# CITY OF ALBUQUERQUE

RE: **Lot 5 Block 5 S.A.D. 227 Unit 28**  
**6508 Onyx Dr. NW**  
**Grading and Drainage Plan**  
**Engineers Stamp Date 1/31/20 (E10D069)**

## DRAINAGE AND TRANSPORTATION INFORMATION SHEET (REV 6/2018)

ENGINEER'S SEAL	<b>LOT 5 BLOCK 5 UNSER CLIFFS SUB</b> <b>6508 ONYX COURT N.W.</b>  <b>GRADING AND DRAINAGE PLAN</b>	DRAWN BY DEM
		DATE 1-31-20
1/31/20		SHEET # <b>C1</b>
DAVID SOULE P.E. #14522	1606 CENTRAL AVENUE SE SUITE 201 ALBUQUERQUE, NM 87106 (505) 972-0899	JOB #

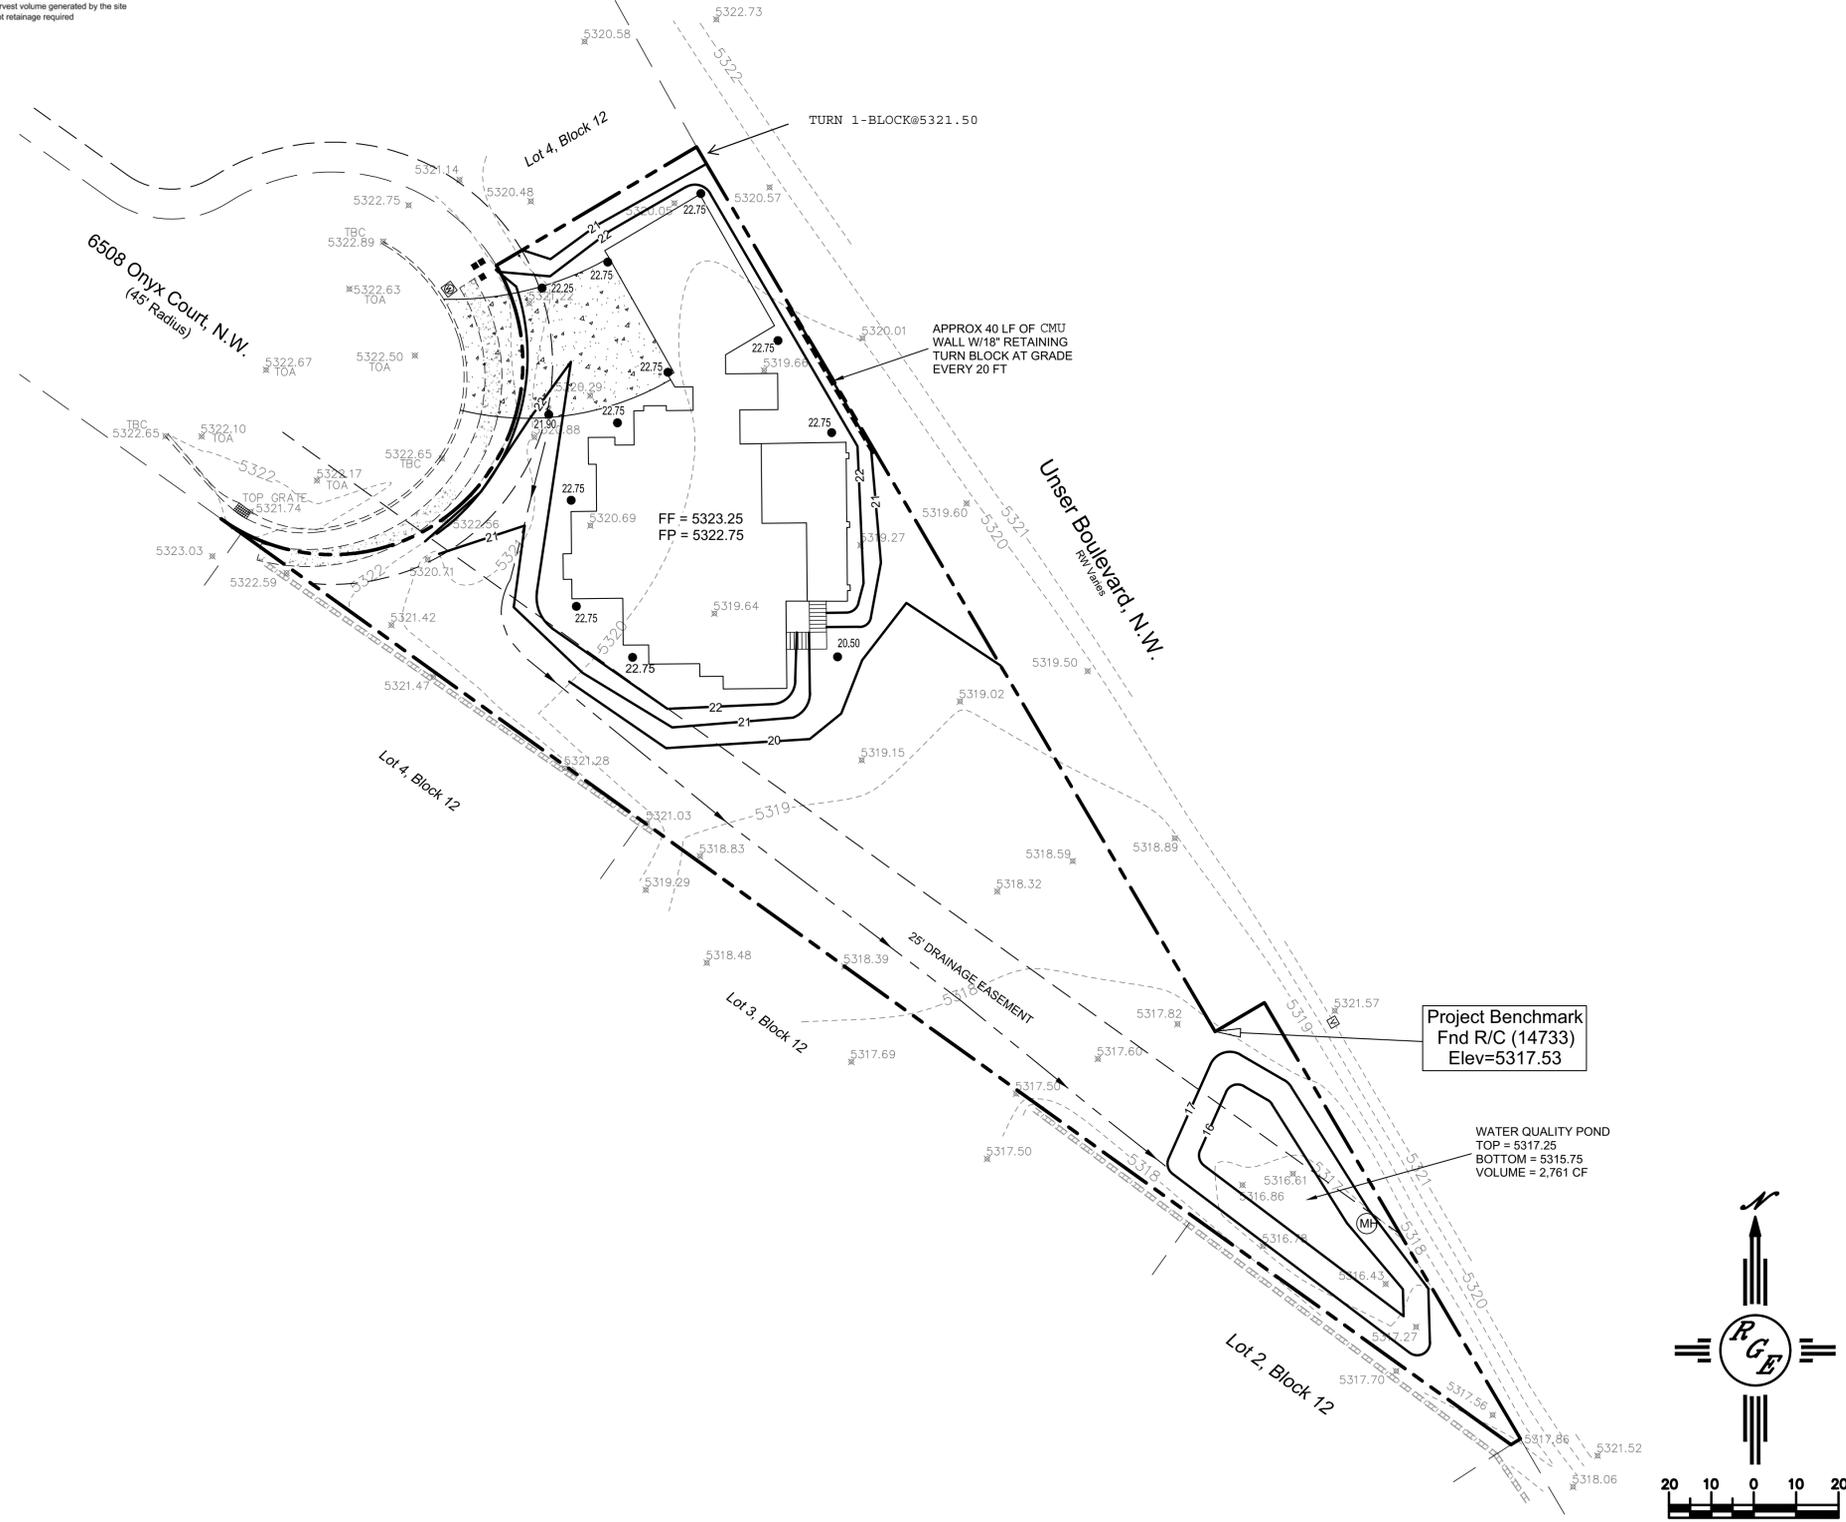
Based upon the information provided in your submittal received 2/3/20, this plan is approved for Grading Permit. Please inform the builder/owner to attach a copy of this approved plan and letter into the construction sets in the permitting process prior to sign-off by Hydrology.

**Reiterate to the Owner/Contractor that a separate permit for any garden/retaining wall must be obtained, with the approved G&D plan.**

Prior to Building Permit approval, a **Pad Certification** will be required. Inform the contractor/owner not to pile dirt in the street as a ramp to climb the curb. If dirt is found in the street the pad cert. will be denied.

Prior to **Certificate of Occupancy release**, Engineer Certification per the DPM checklist of this plan will be required.
